**COMMENTS AND ANALYSIS RELATED TO OPEN SPACE
SCHLOTZSKY PUD REZONING CASE C814-2018-0121 (218 S LAMAR)
by Zilker Neighborhood Association (31 Oct 2020)**

Illustration of Ground Level Spaces (based on drawings in applicant's submittals)

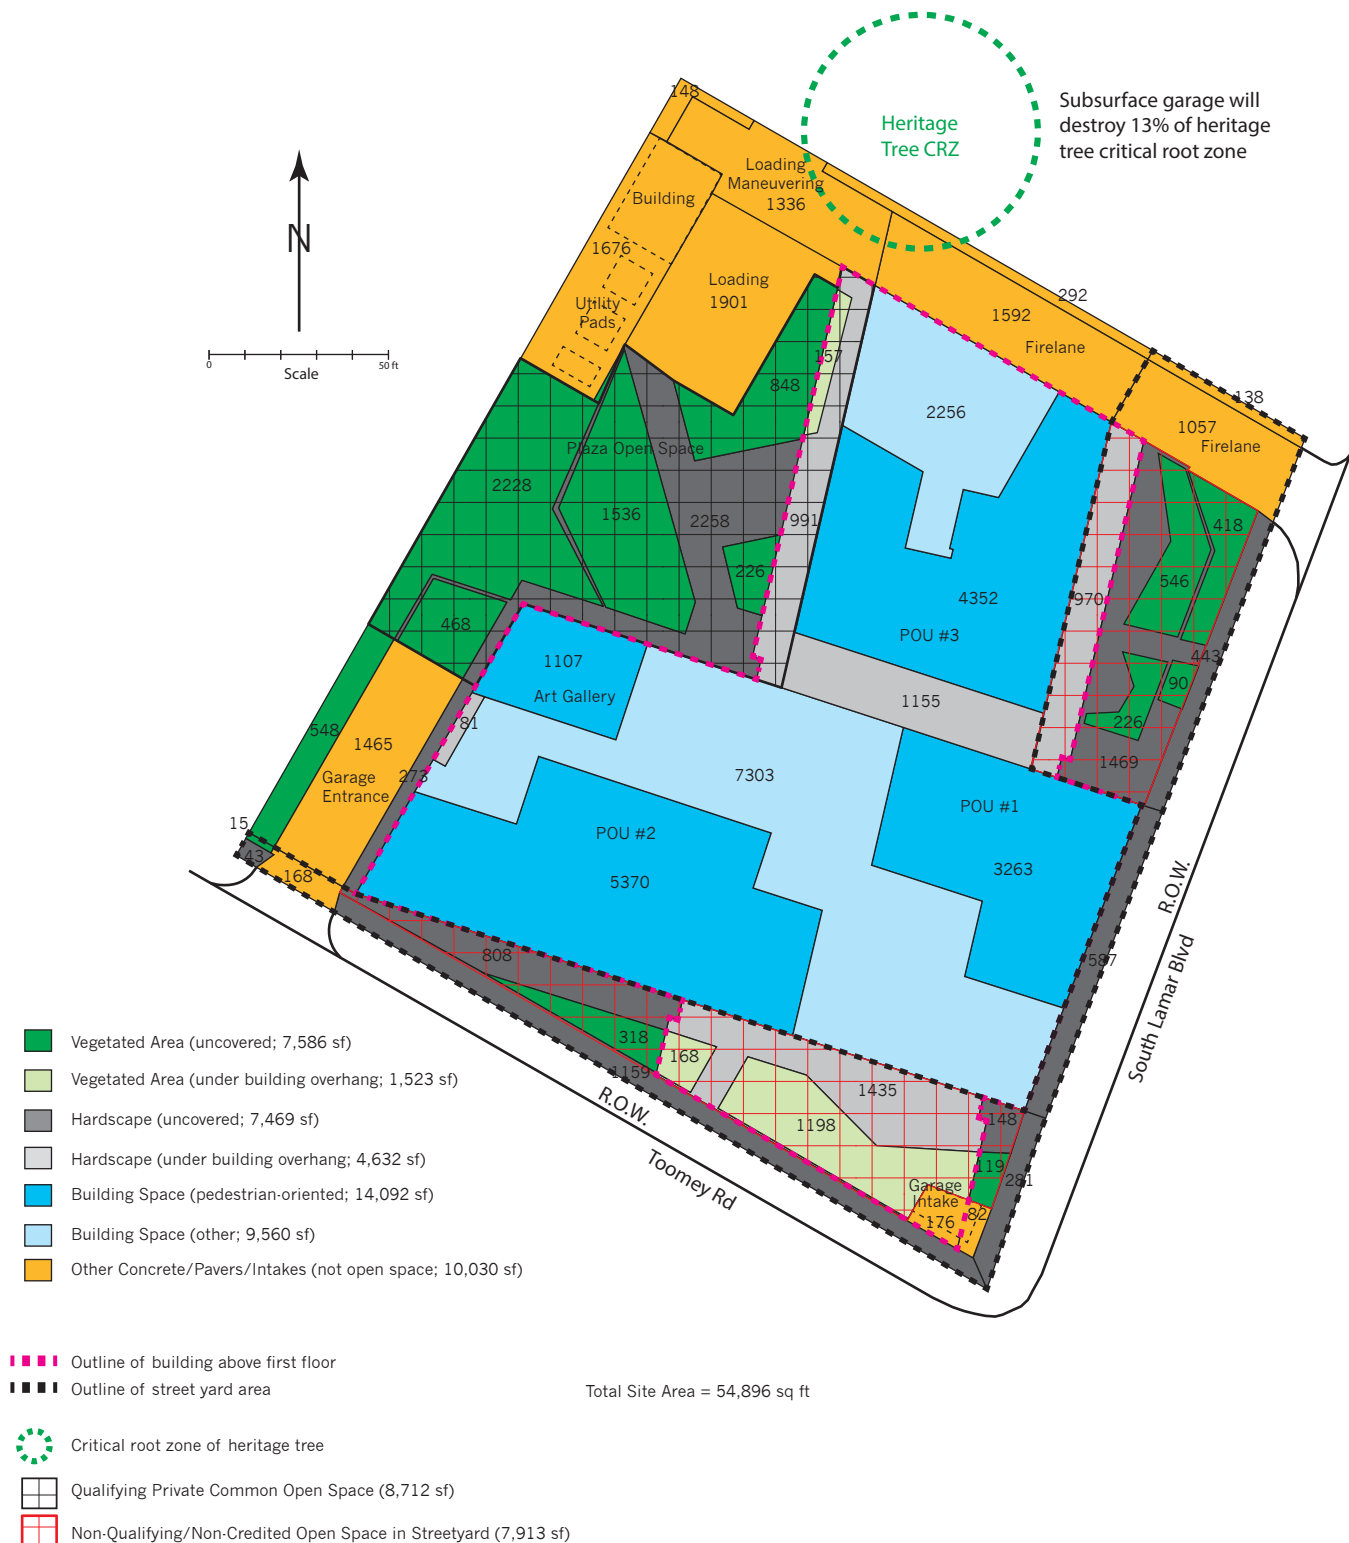
Based on standard #2 in §2.7.3.A and limitations #1 and #3 in §2.7.3.C above, the PUD cannot take open space credit for land that is in the street yard, for strips of land that are less than 20 feet wide, or for land in loading areas, driveways or service areas, which is exactly what the PUD has done in its July 15 Addendum 1 Exhibit of the open space. While the City staff did exclude the loading area in its latest review, it did not exclude those areas less than 20 feet wide and it included street yard space that is not allowed to be credited. Based on the Subchapter E standards and limitations, ZNA believes the actual provided open space is only 15.9% and requests that City Council reject the PUD rezoning based on its failure to meet even the Tier One 20% open space requirement.

Numbers shown are square footages based on applicant's drawings
(estimated, but probably within 0.5% of the actual numbers)
